PROPOSED RENOVATION OF

The Kalian Residence

99 Byram Ridge Road,
Armonk, NY

PROPOSED
ONE FAMILY
DWELLING
EXPANSION

1 SITE PLAN
Scale: 1/16" = 1'-0"

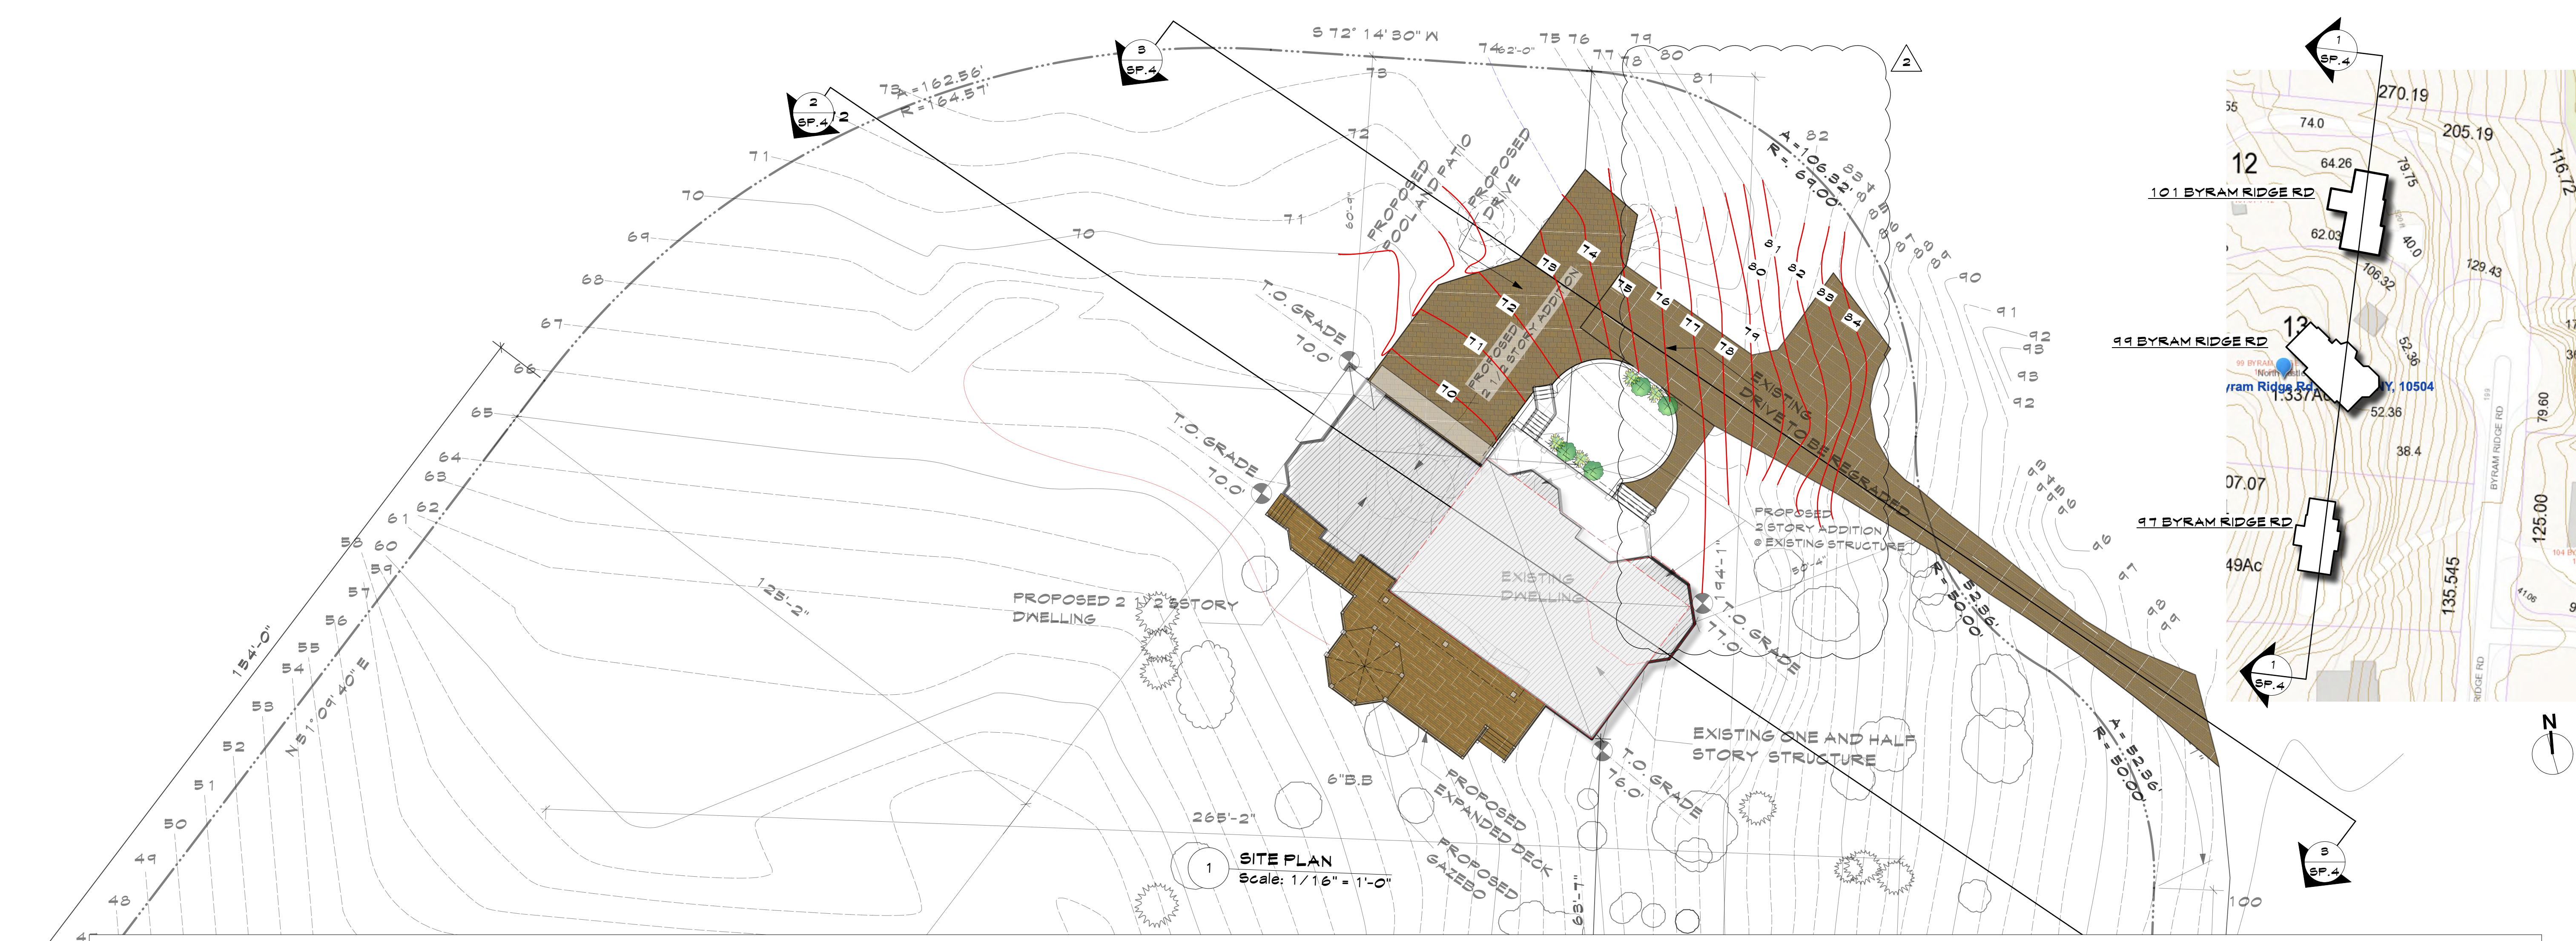
4. As previously requested, the plan shall illustrate and dimension all required minimum yard setbacks.
5. As previously requested, the plan shall illustrate any proposed grading, including spot grades, as appropriate and coordinate same between both plan sets.

3. The plans have been clarified and coordinated.
4. Minimum yard setbacks have been illustrated on Sheet SP.2.
5. Proposed grading shown on Sheet SP.4 and coordinated on SP.1, SP.2 & SP.3.

Project ID / DATE : 2048 / 10.15.2020
Sheet Scale:
SP.4
Drawn By: KM Checked By: TFA
Plot Date: APR.14.2021

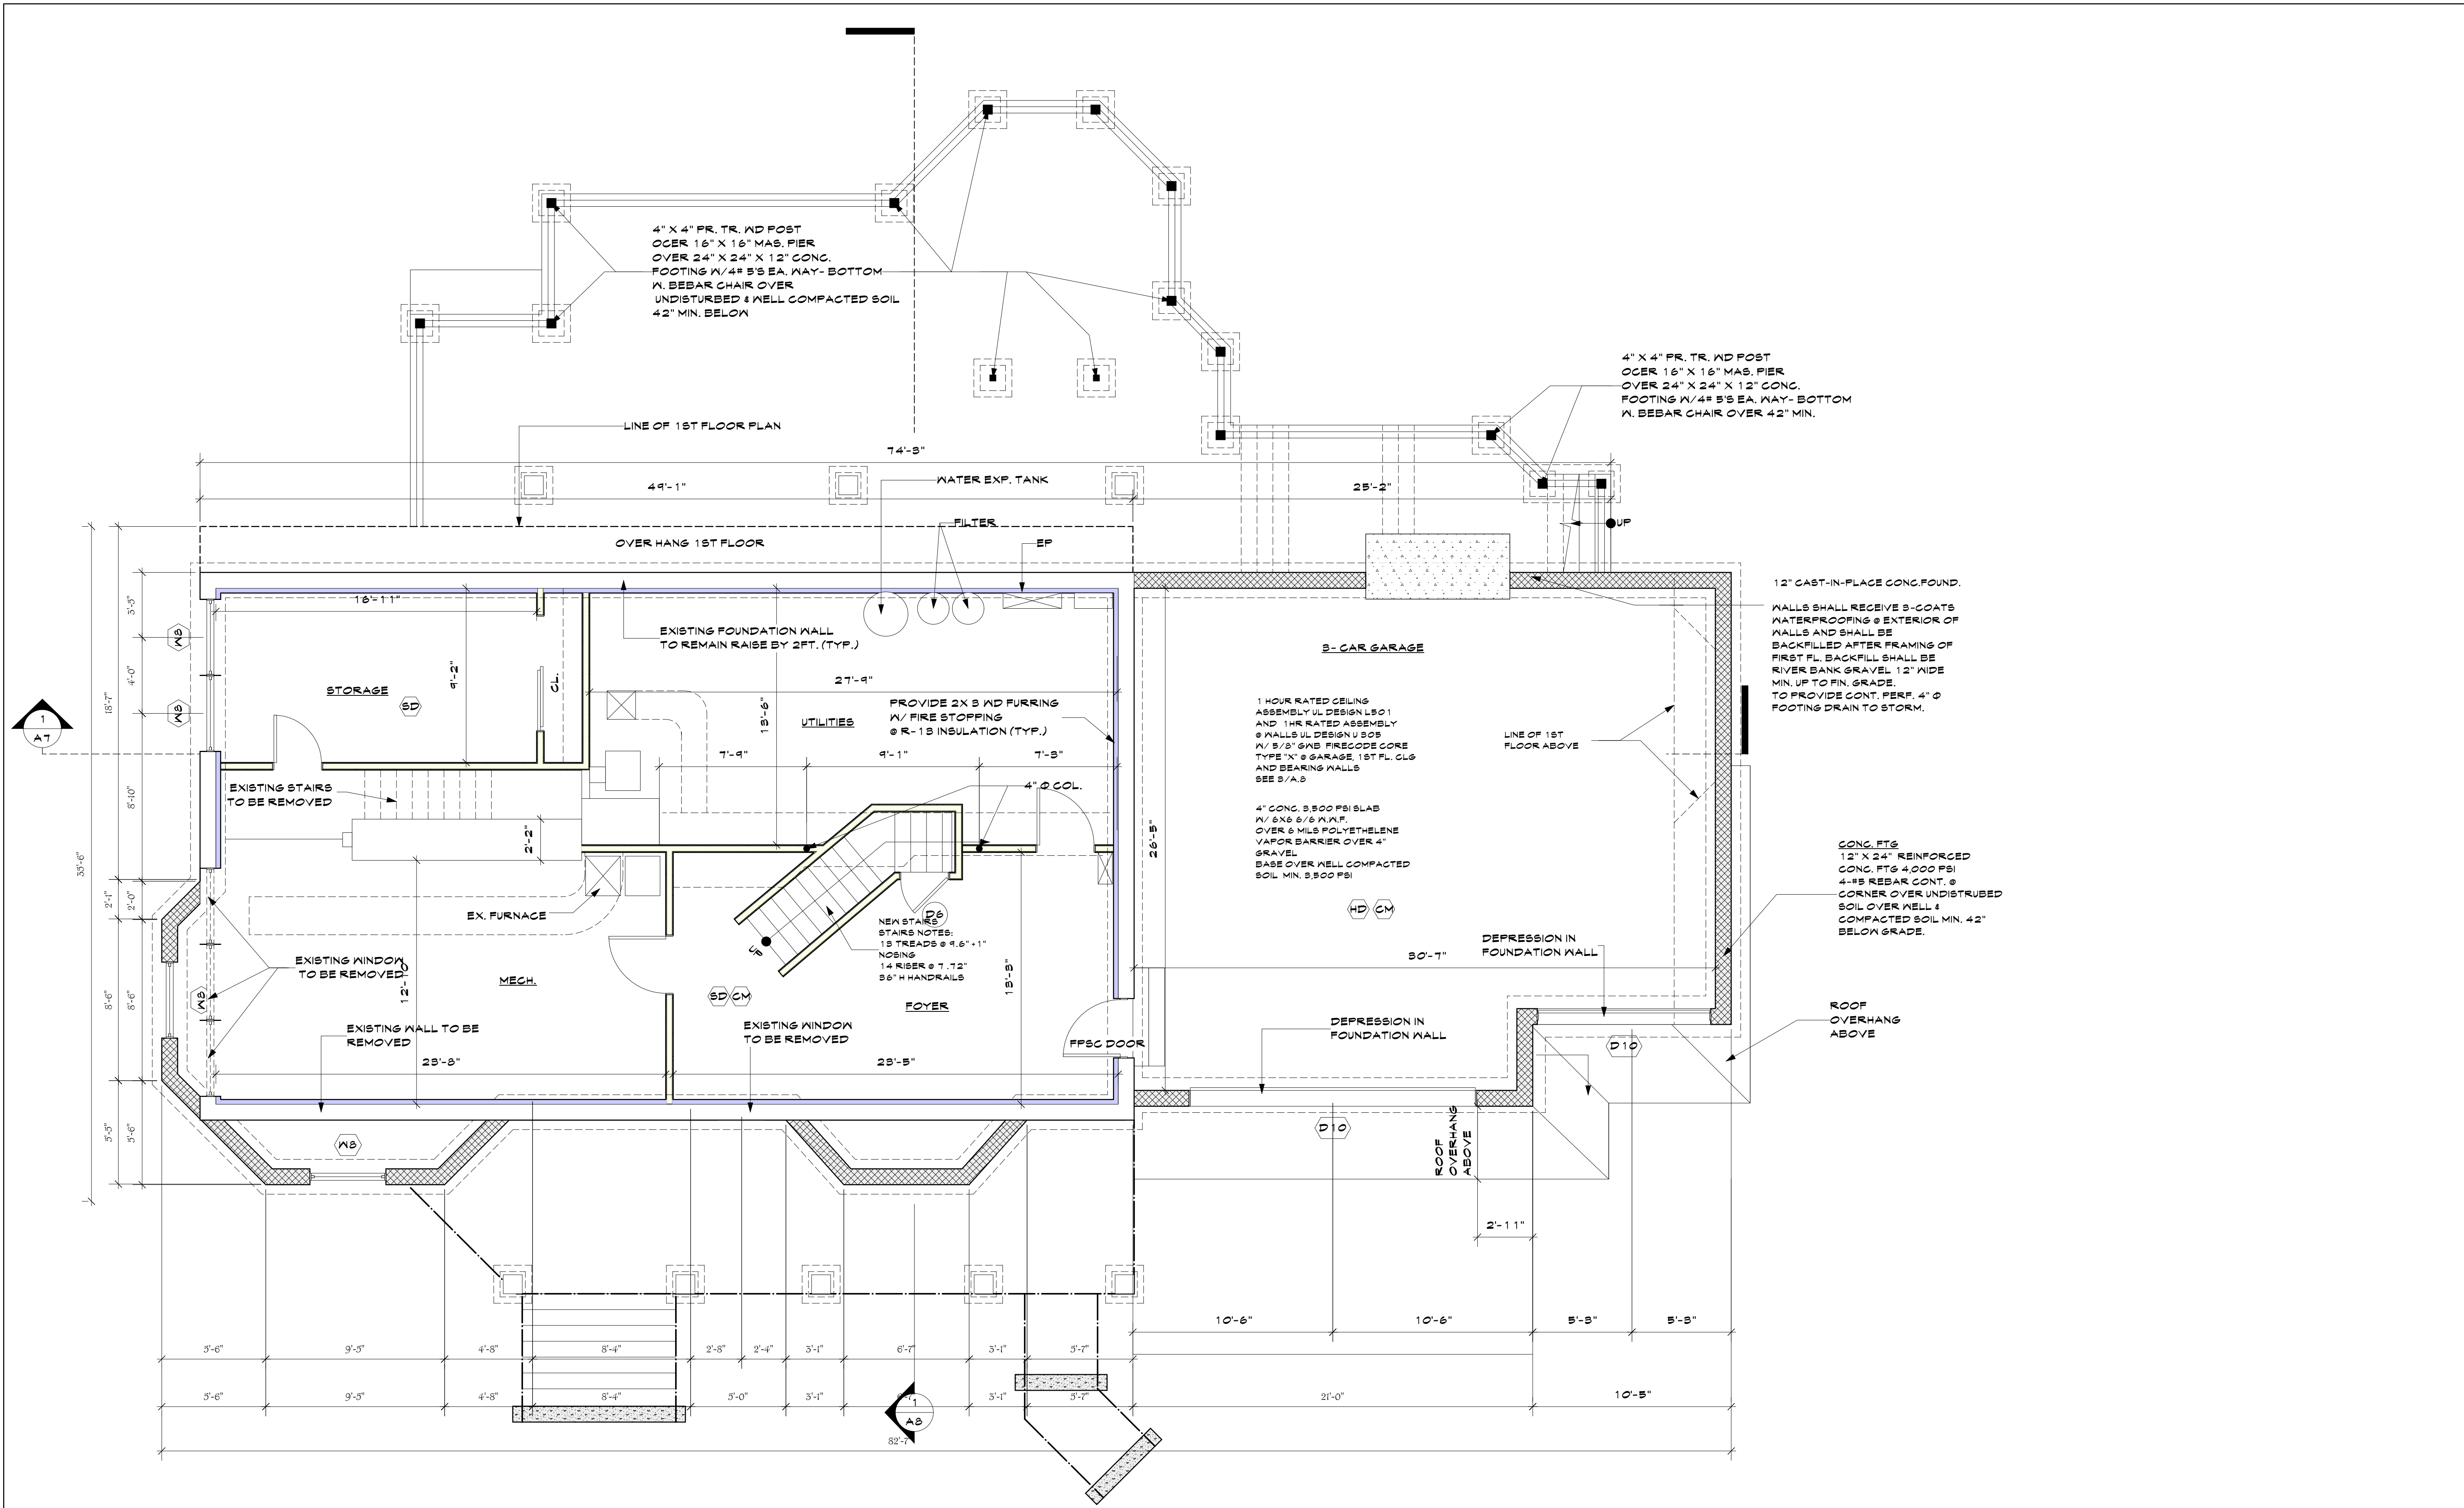
8. The plan shall include a driveway profile demonstrating compliance with Section 355-59, Driveways of the Town Code. The profile shall include dimensions, grades and vertical curve data as needed. The plan shall also indicate a maximum curb cut width of 18 ft as required by the Town Highway Department. Any required restoration within the Town right of way shall be illustrated and detailed on the plan.

8. Sheet SP.4 shows existing and proposed driveway profile in compliance with Section 355-59, Driveways of the Town Code.
9. **See responses to comments #9 thru #14 from ARQ.**
